寄件者: Thomas Wan <[REDACTED]>
寄件日期: 2026年10月13日星期二 14:30
收件者: William Shu Tai WONG/PLAND
副本: Kit Lo; Johnny Chung Yin LAM/PLAND; Adrian Tsz Hin TAM/PLAND
主旨: RE: Planning Application No. A/NE-MUP/236
附件: RE: Planning Application No. A/NE-MUP/236; Lots 188(Part) and 189RP, Demarcation District No.38 (4).pdf

Application Location:
Lots 188(Part) and 189RP,
Demarcation District No. 38

寄件者: Ray Hung Wai LAM <hungwailam@td.gov.hk>
寄件日期: 2026年10月09日星期五 14:37
收件者: Kit Lo
副本: Thomas Wan
主旨: RE: Planning Application No. A/NE-MUP/236
附件: Lots 188(Part) and 189RP, Demarcation District No.38 (4).pdf

Drawing Title:
Swept Path Plan

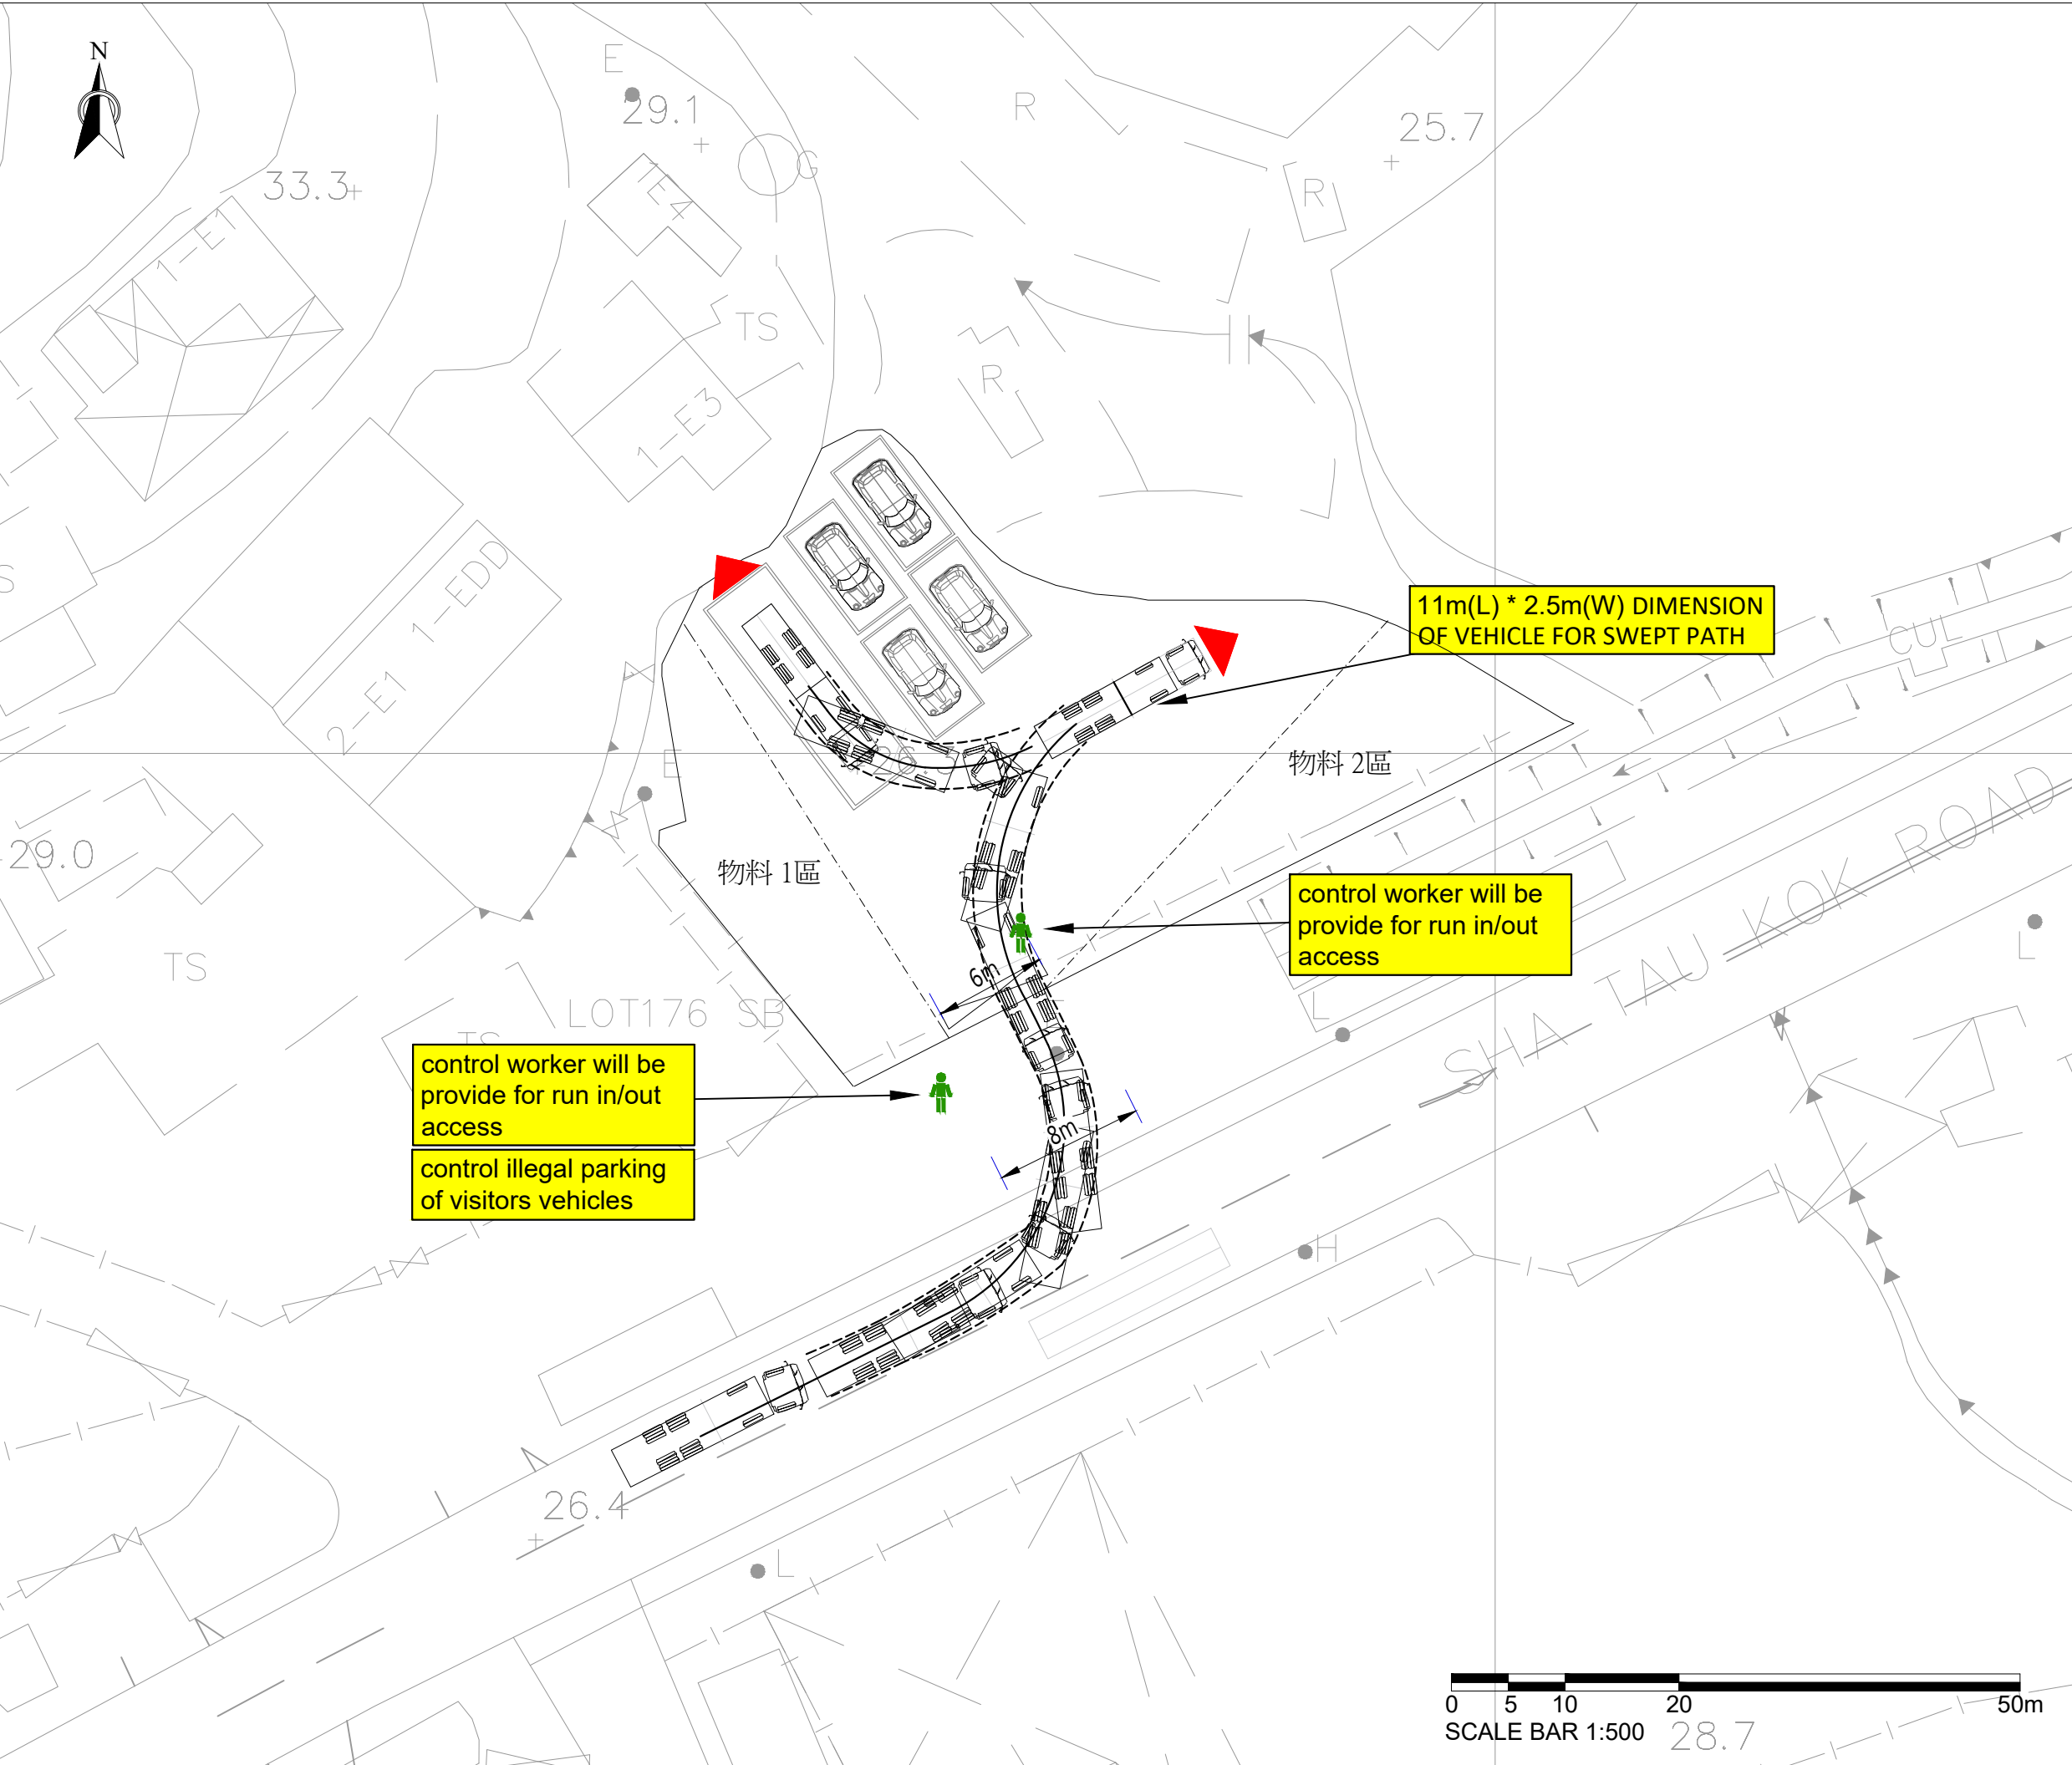
Please also advise the width of the run-in/out.

1. The submitted swept path analyses do not accurately reflect the actual situation of the maneuvering of the 11m x 2.5m heavy goods vehicles entering and exiting the subject site. The applicant should rectify it;
2. The applicant should ensure the HGV would not encroach onto the opposite lane when entering/leaving Sha Tau Kok Road to/from the application site; and
3. The applicant should specify the width of the run-in/out.

DWG updated with run in / out around 8M.
